**Project Number:** SP2018-024  
**Project Name:** MEDICAL OFFICE BUILDING  
**Project Type:** SITE PLAN  
**Applicant Name:** PSA ENGINEERING, LLC  
**Owner Name:** ROCKWAY, PARTNERS LLP  
**Project Description:**

**RE: SITE PLAN (SP2018-024), MEDICAL OFFICE BUILDING**

## City of Rockwall Project Plan Review History

SHEET: C-01

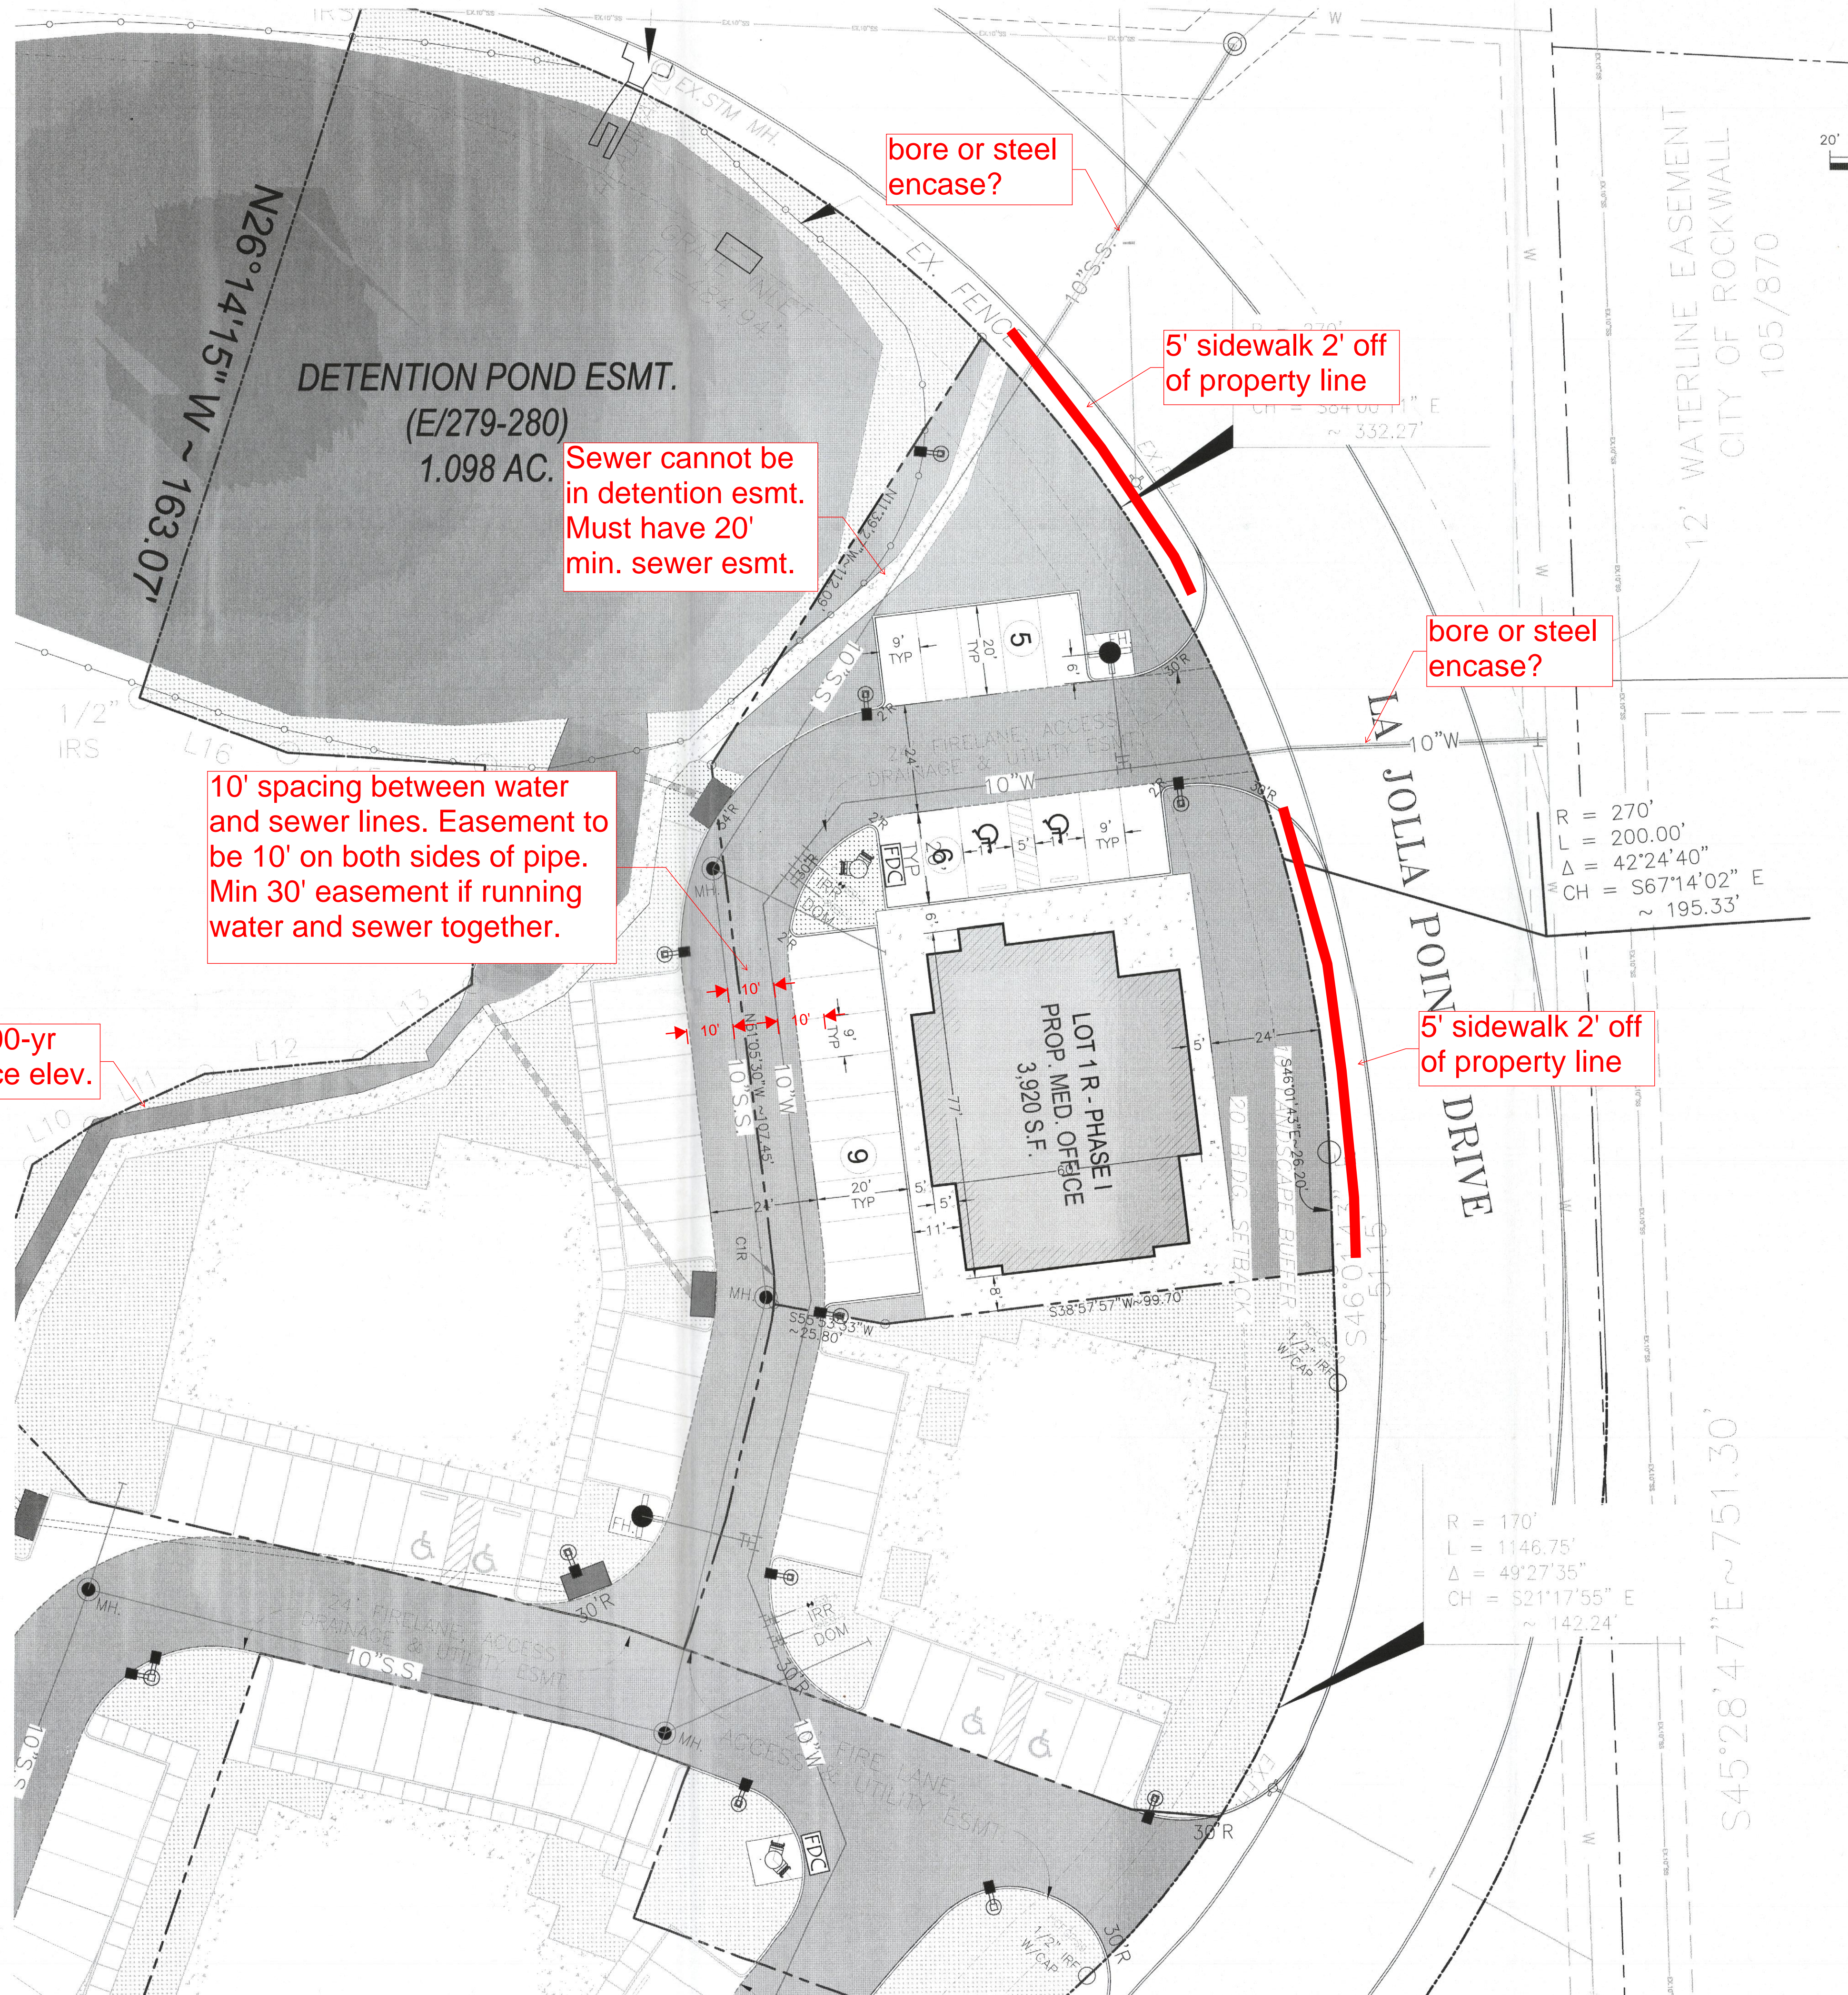
10' spacing between water and sewer lines. Easement to be 10' on both sides of pipe. Min 30' easement if running water and sewer together.

Sewer cannot be in detention esmt. Must have 20' min. sewer esmt.

bore or steel encase?
